**ADDENDUM NO. 1**

**AUTOMATED PEOPLE MOVER OPERATING SYSTEM  
SUPPLIER ELIGIBILITY DETERMINATION**

**LANDSIDE ACCESS MODERNIZATION PROGRAM**

**LOS ANGELES INTERNATIONAL AIRPORT**

PROFILES ARE BASED ON NORTH TRACK; SOUTH TRACK TO BE SIMILAR

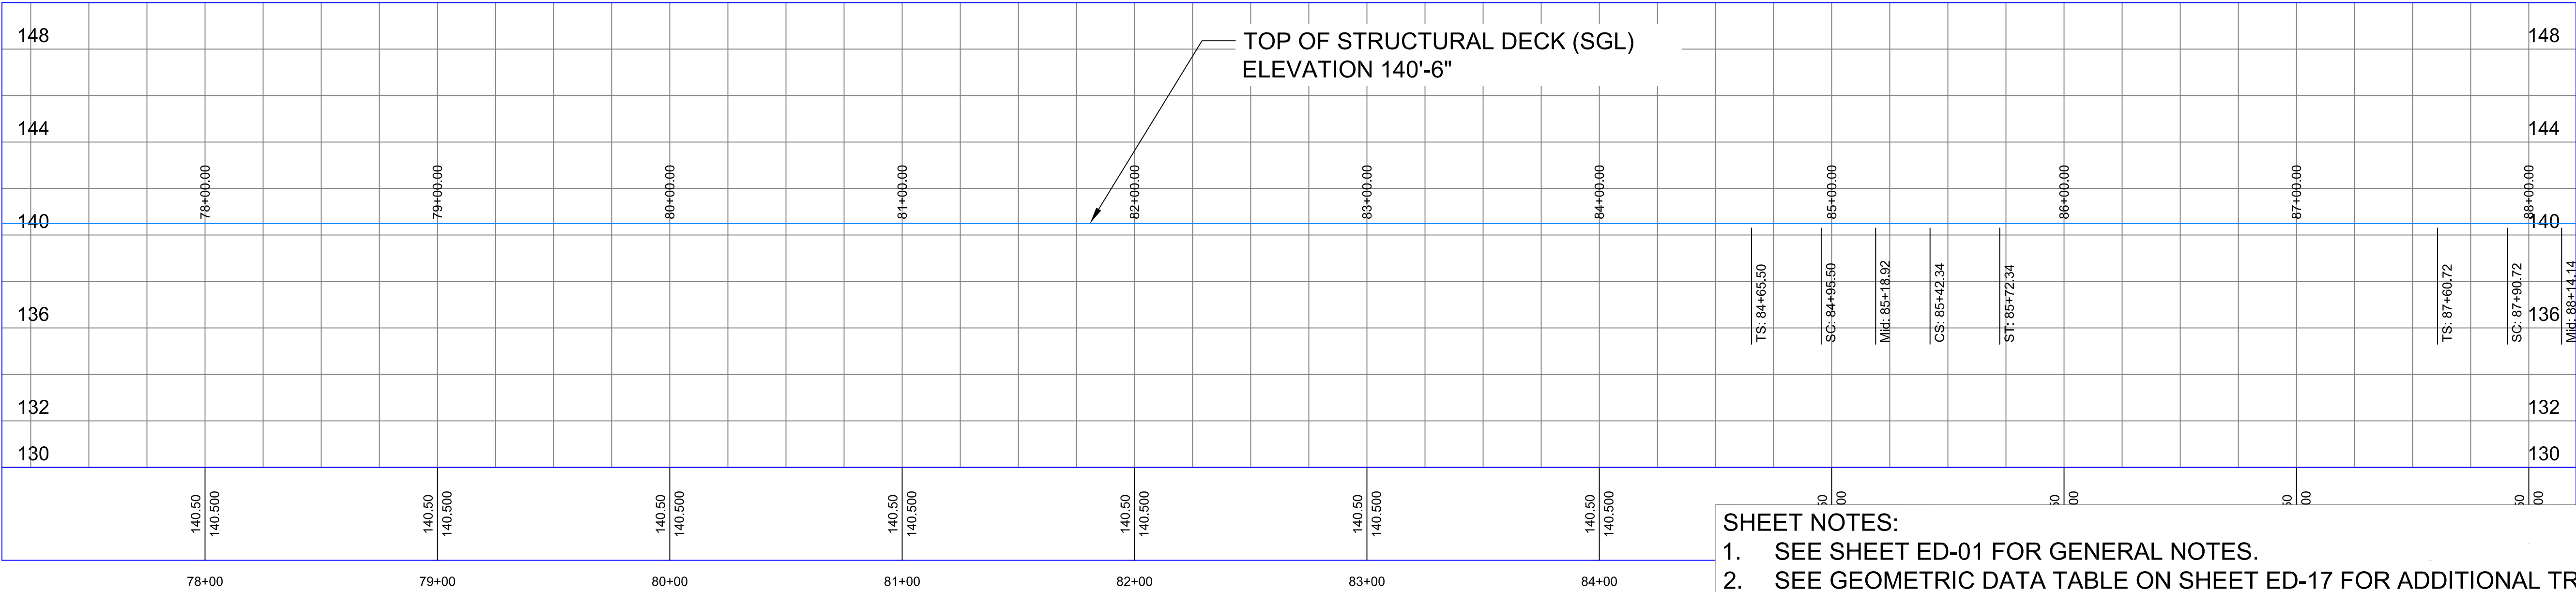
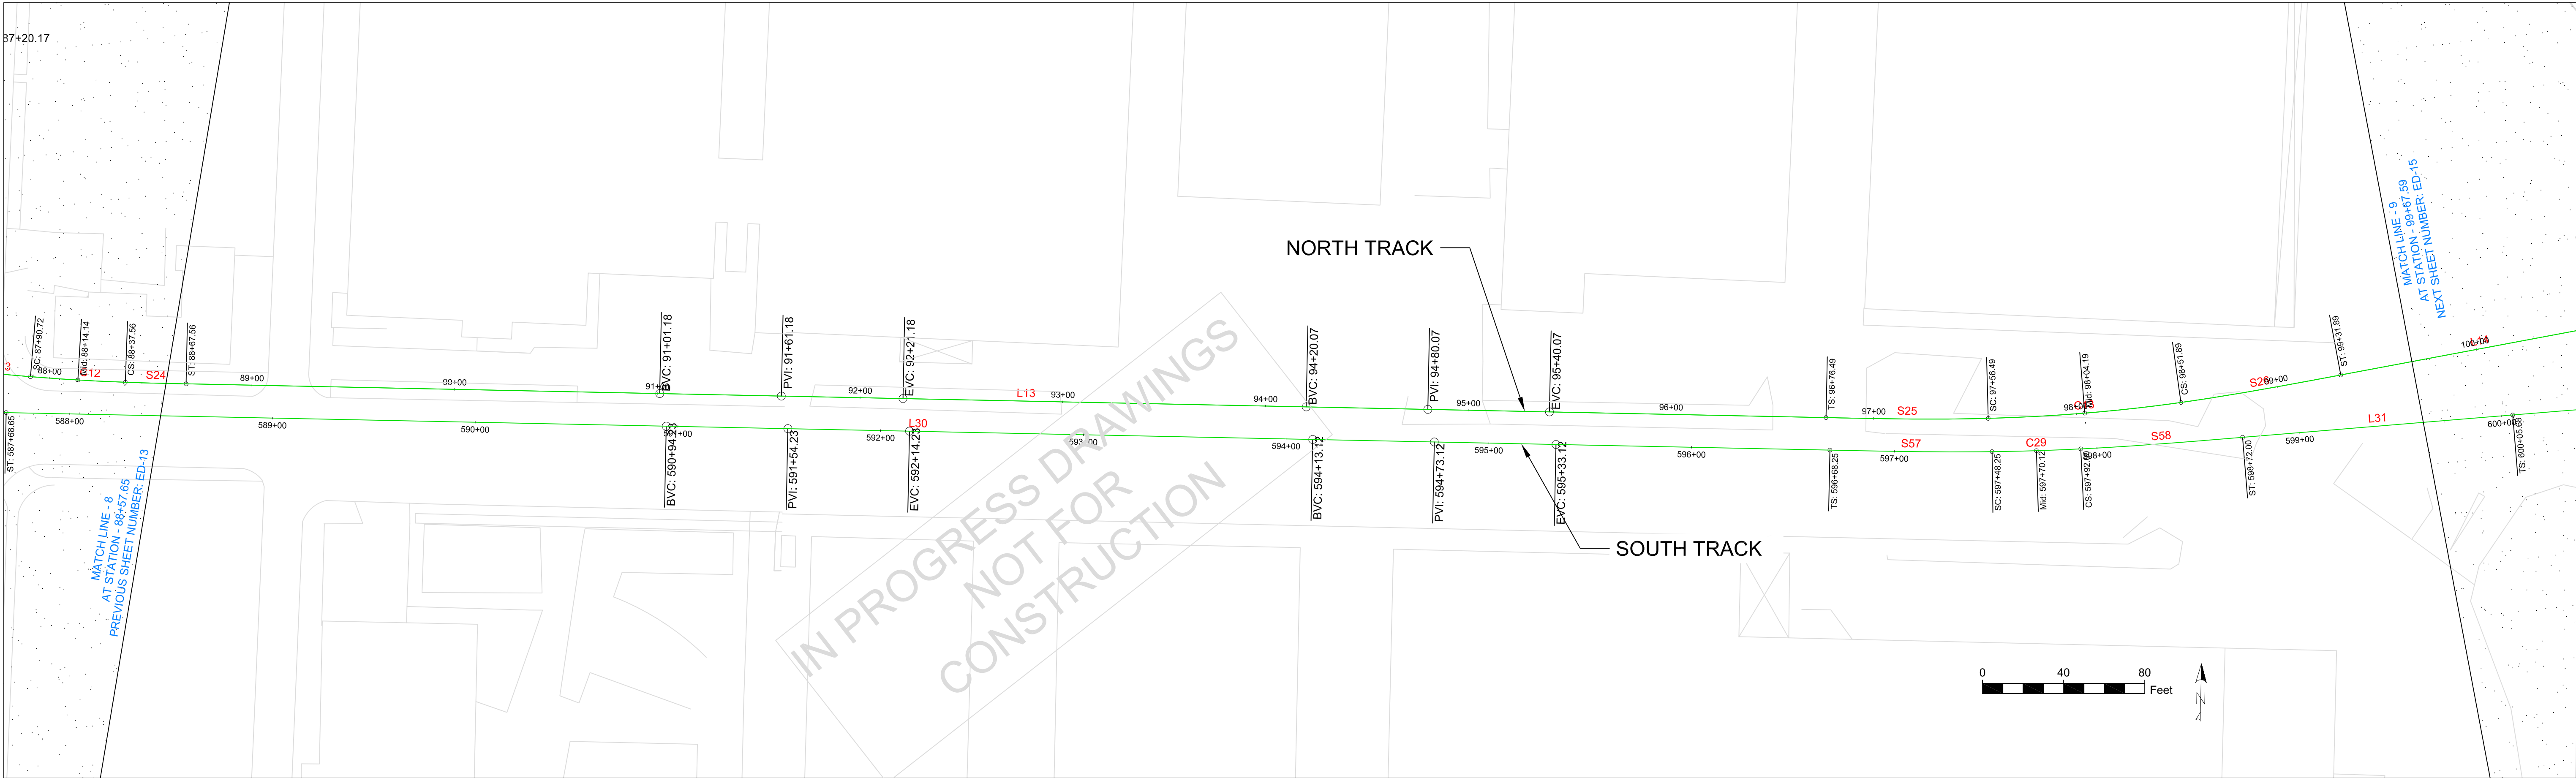
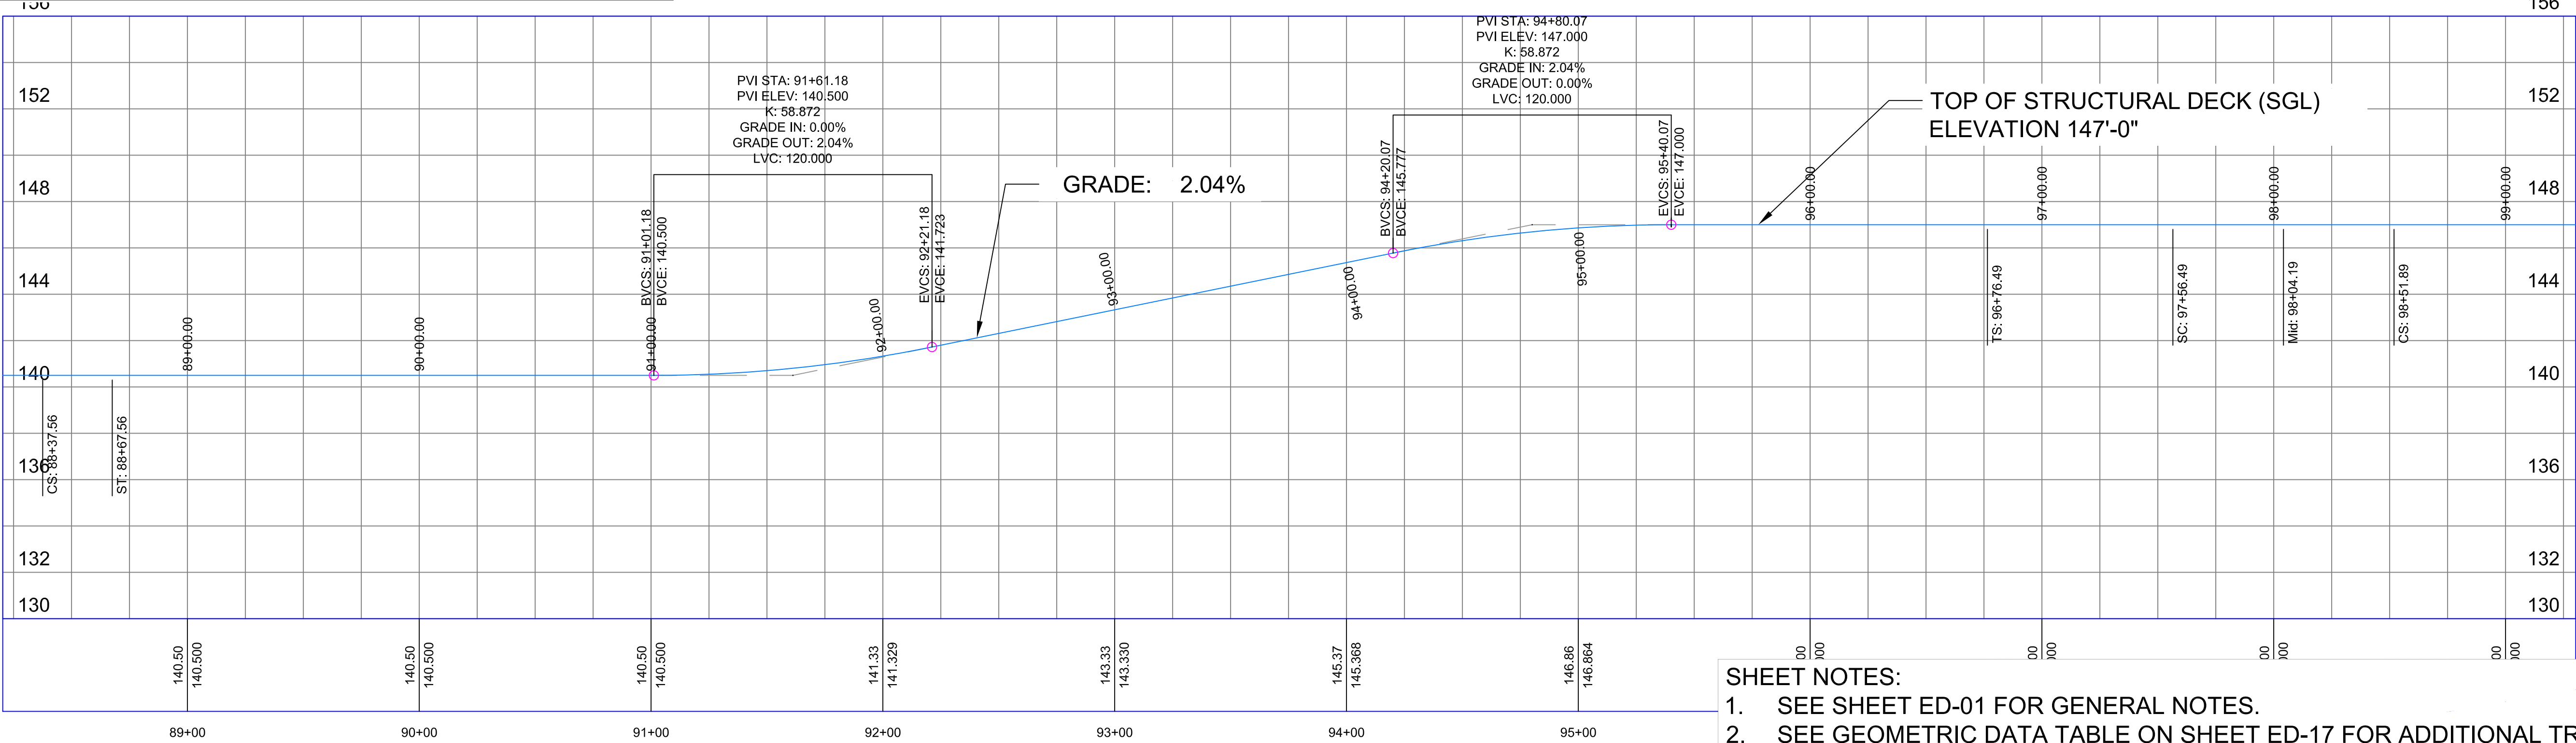
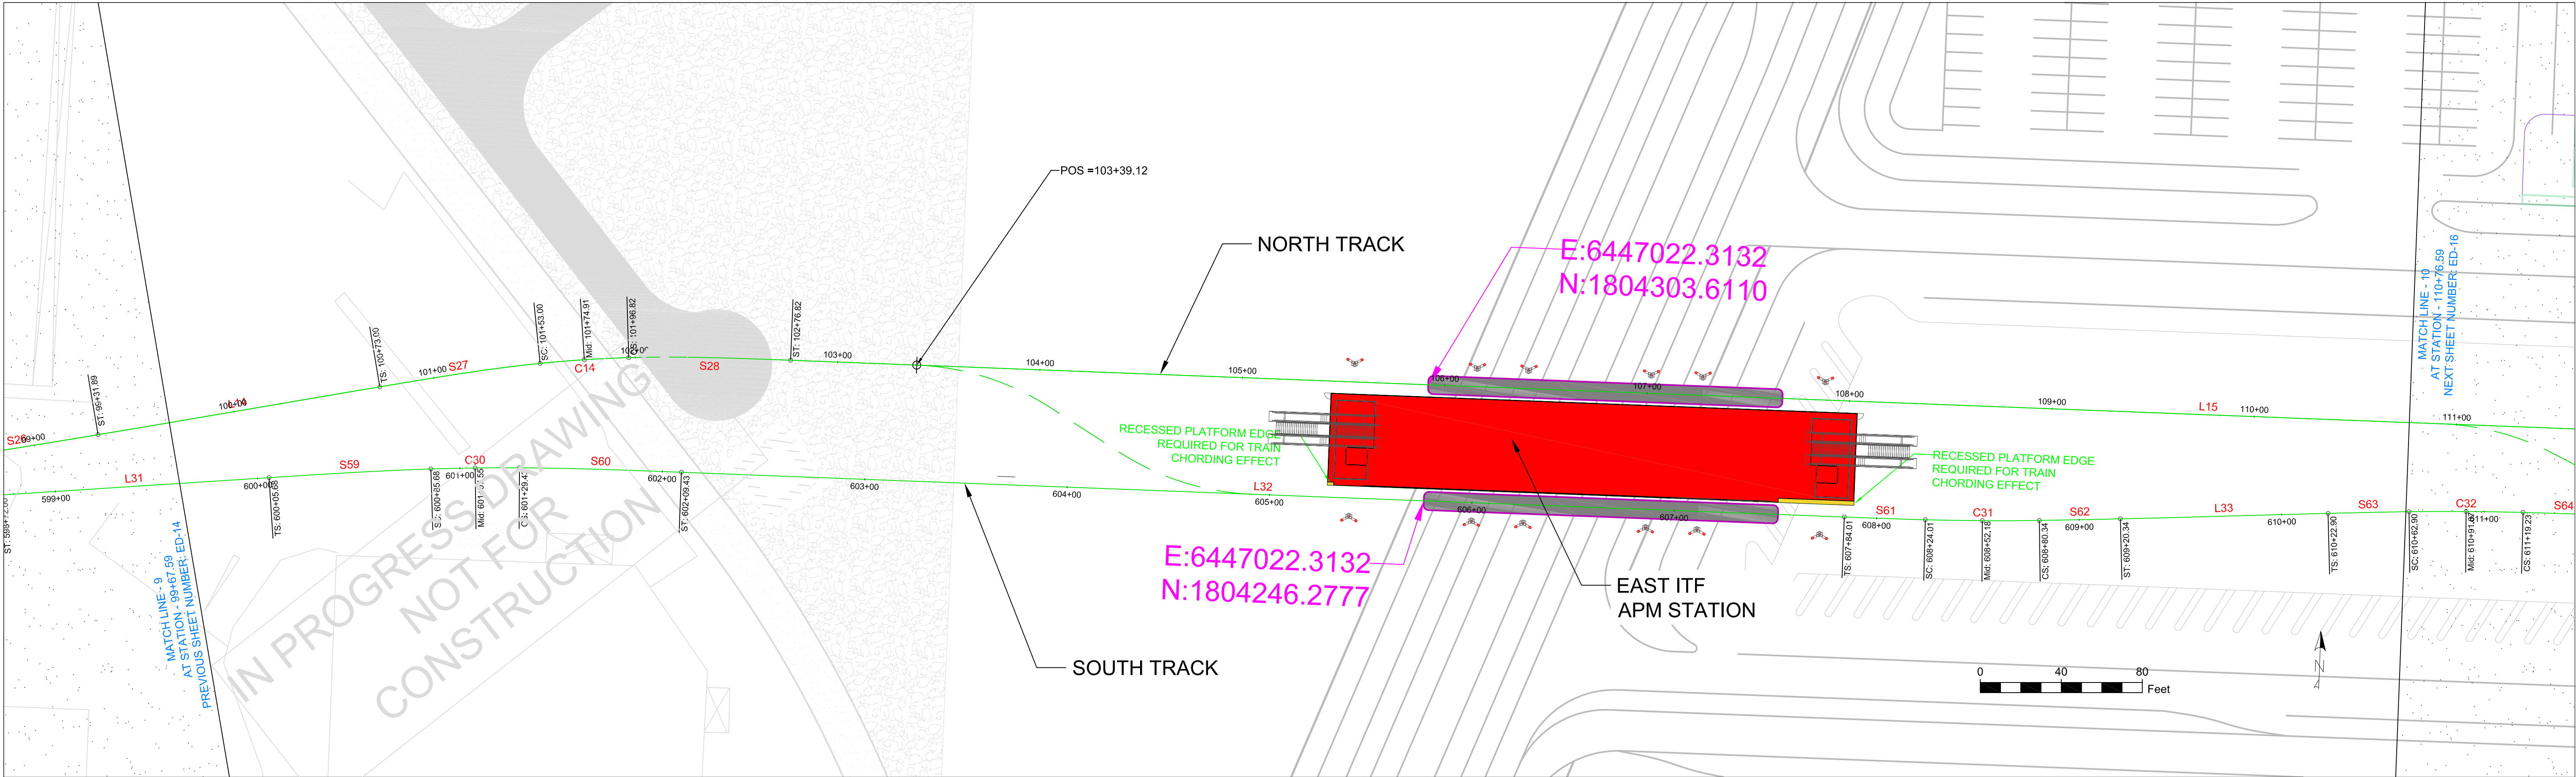
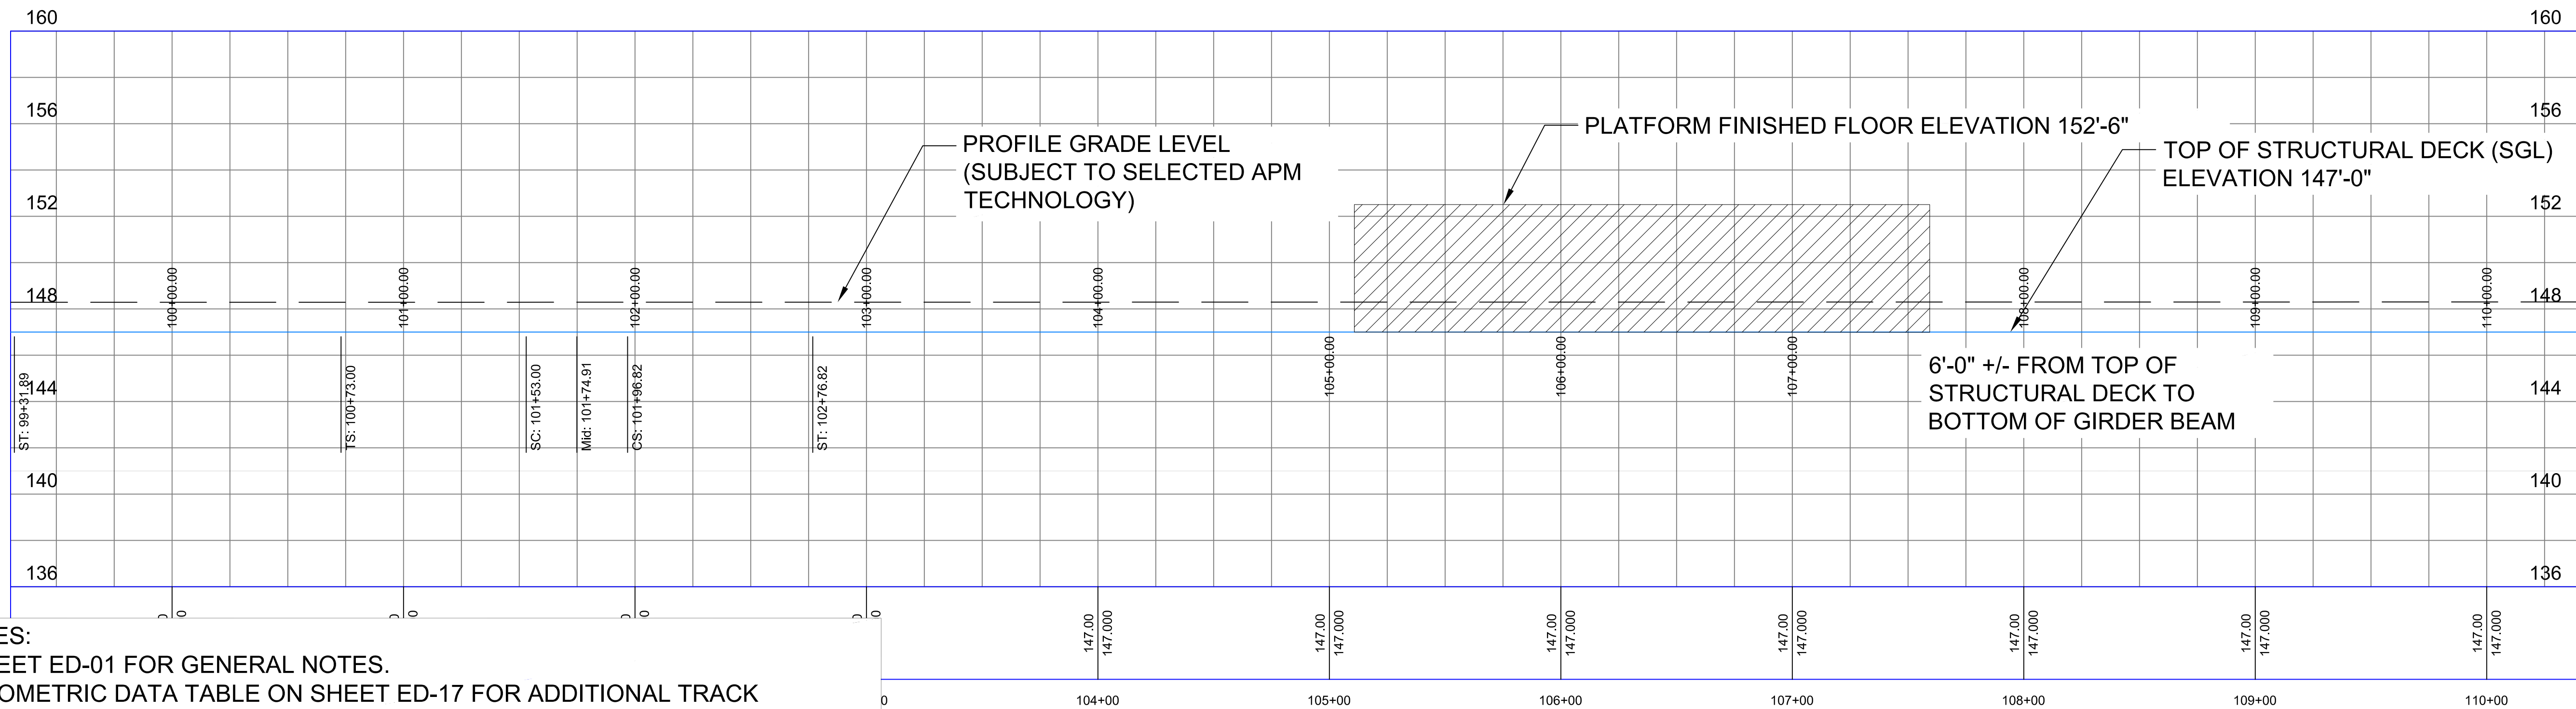
**RFC 5 :** Attachment 4 – Sheets ED-17 and ED-18. We reviewed and re-created the alignment stationing and find that there is a discrepancy between the alignment stationing (created from the curve data) and the alignment stationing shown on sheets ED-09 through ED-16. A similar discrepancy is observed on Sheets ED-03 through ED-05. Please clarify.

- a. Replace sheets ED-04, ED-05, ED-09 through ED-16, and ED-19 with attached sheets ED-04, ED-05, ED-09 through ED-16, and ED-19, Addendum 1 – May 5, 2016. Revised sheets incorporate a correction to the stationing on the sheets.

**RESPONSE 5:** Refer to the revised Sheets ED-04, ED-05, ED-09 through ED-16, and ED-19 for Attachment 4 in Addendum 1 – May 5, 2016.
